IN THE DRAWINGS:

REMARKS

In order to place this application in better condition for a complete action on the merits, the specification has been suitably revised to correct informalities and to place it in better conformance with U.S. practice. A proposed revision has been submitted in Figs 5, 8, 9, 10, 11, 12 and 15-16 to separately label each of the views. Claims 1, 2 and 15-26 have been amended in formal respects to improve the wording and bring them into better conformance with U.S. practice. Attached hereto is a marked-up version of the changes made to the specification and claims by the current amendment. The attached pages are captioned **"VERSION WITH MARKINGS TO SHOW CHANGES MADE."**

~~FIG.5~~

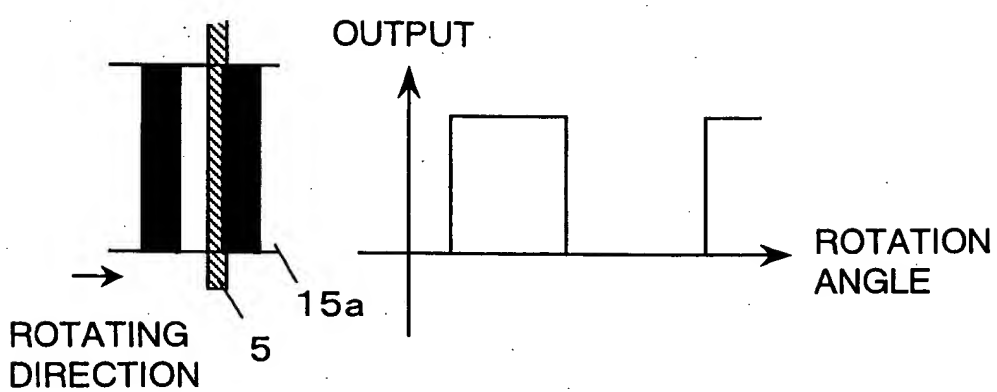
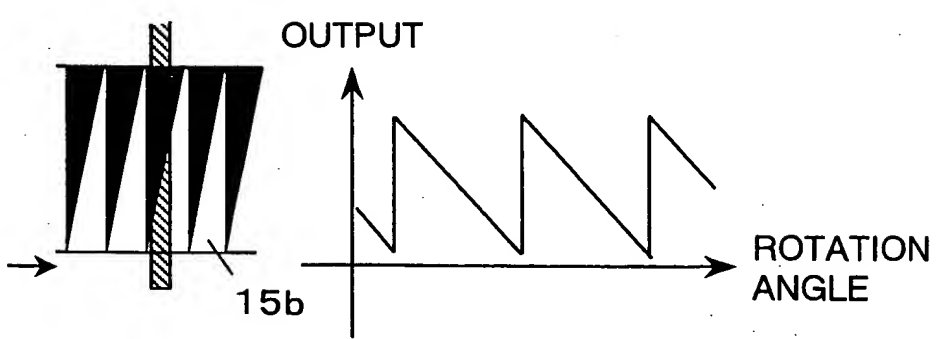
FIG.5 (A)

FIG.5(B)

~~FIG. 8~~

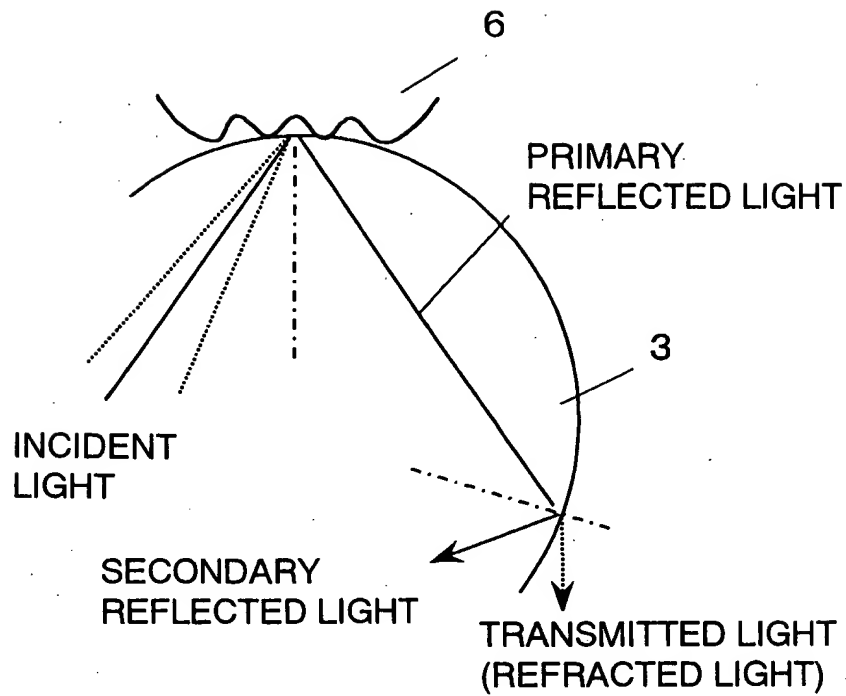
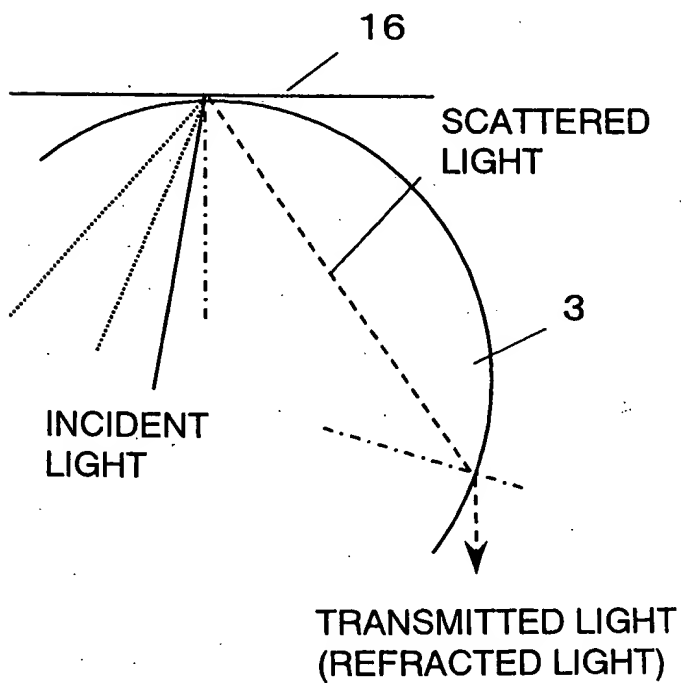
FIG. 8(A)

FIG. 8(B)

~~FIG. 9~~

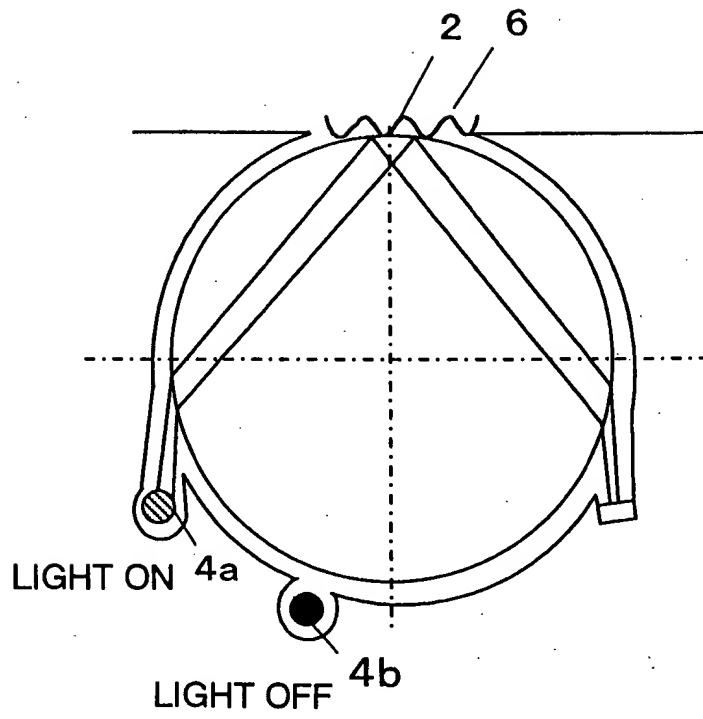
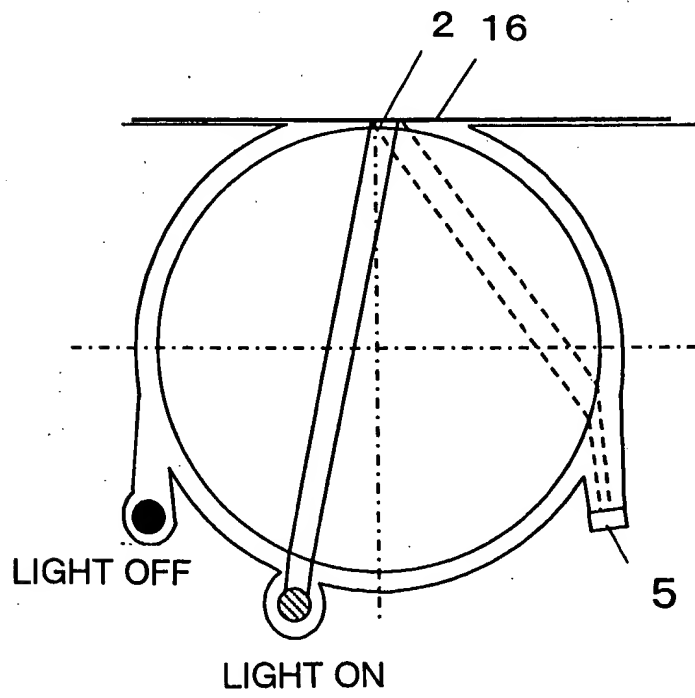
FIG. 9(A)

FIG. 9(B)

~~FIG. 10~~

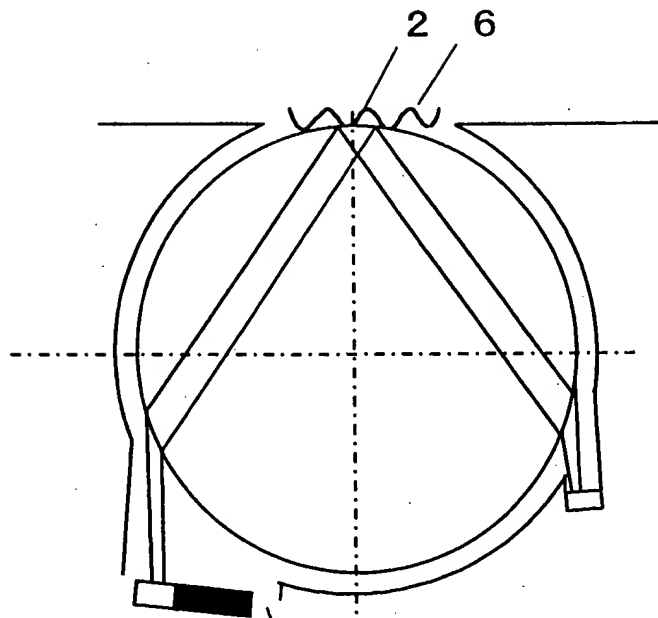
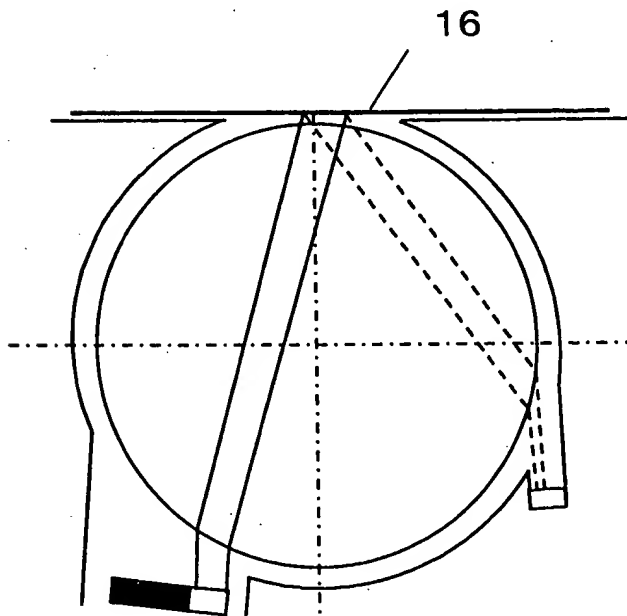
FIG. 10(A)

FIG. 10(B)

~~FIG. 11~~

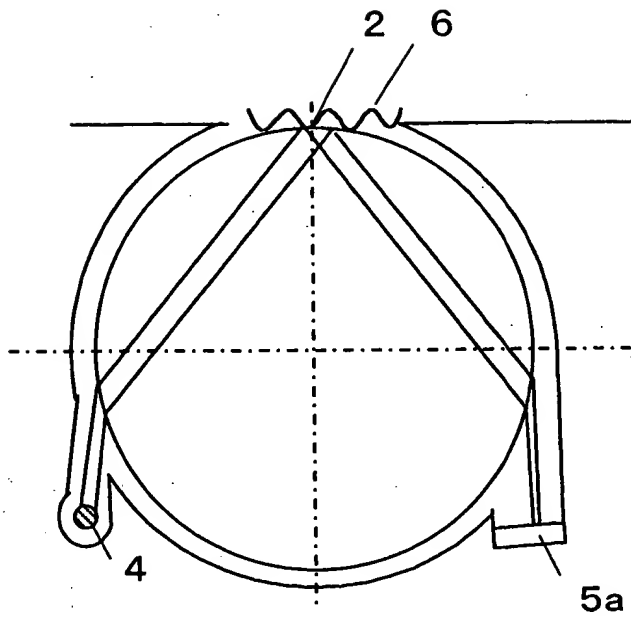
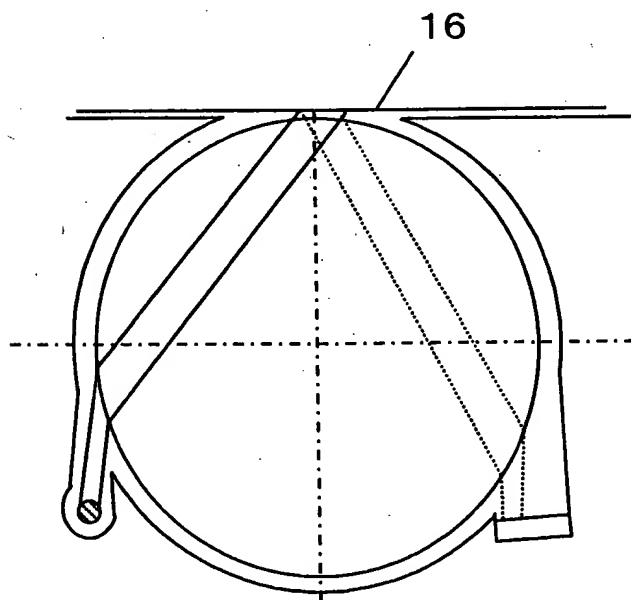
FIG. 11 (A)

FIG. 11 (B)

~~FIG. 12~~

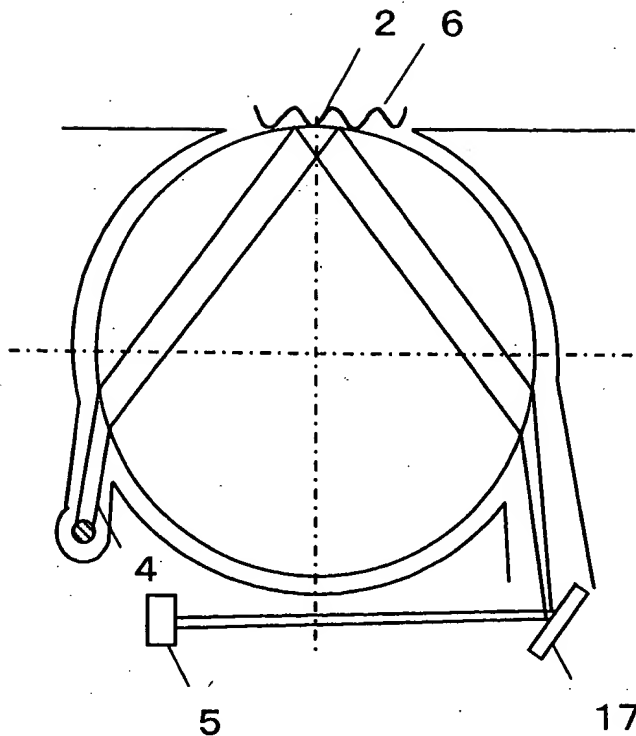
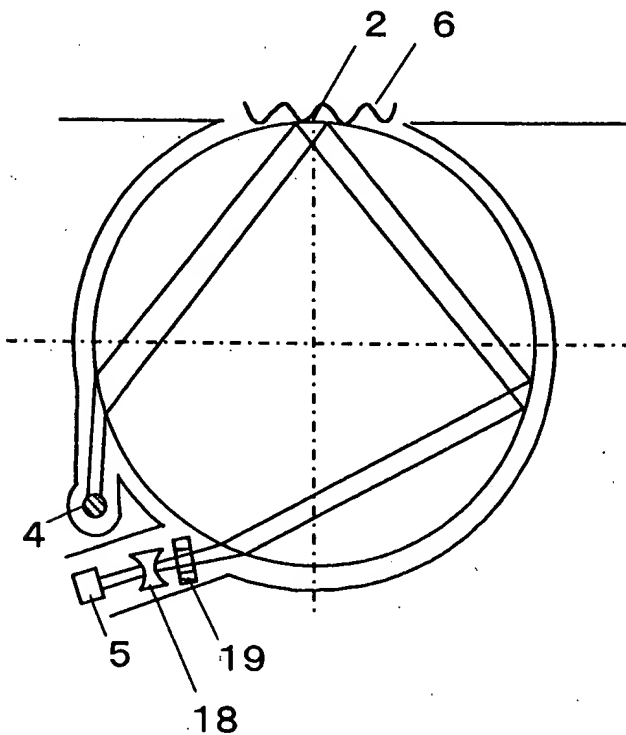
FIG. 12 (A)

FIG. 12 (B)

~~FIG. 16~~

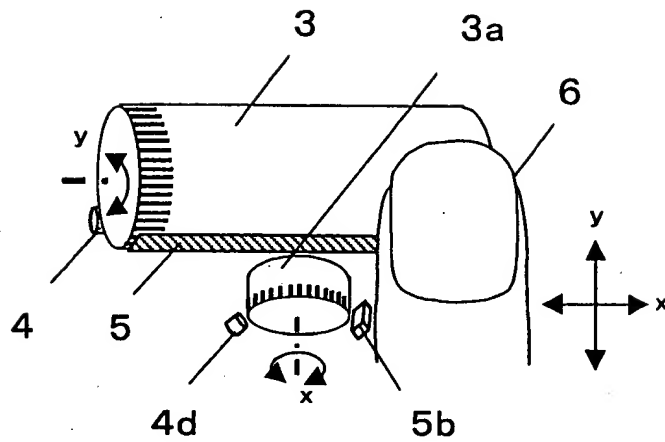
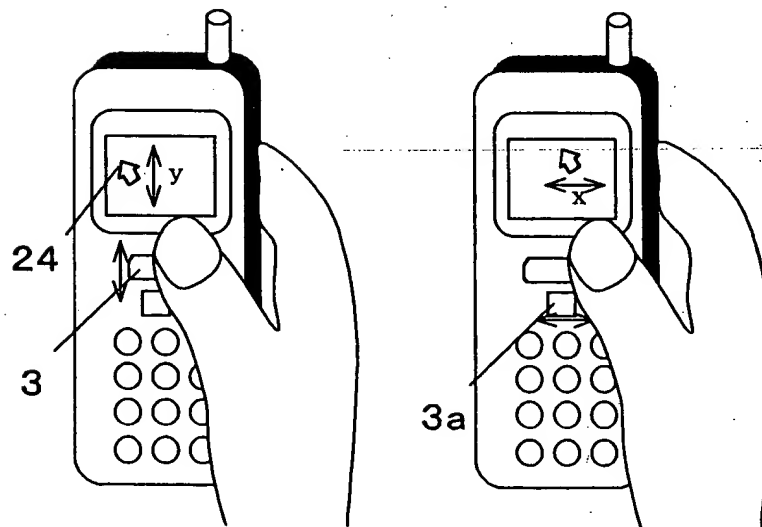
FIG. 16 (A)

FIG. 16 (B)
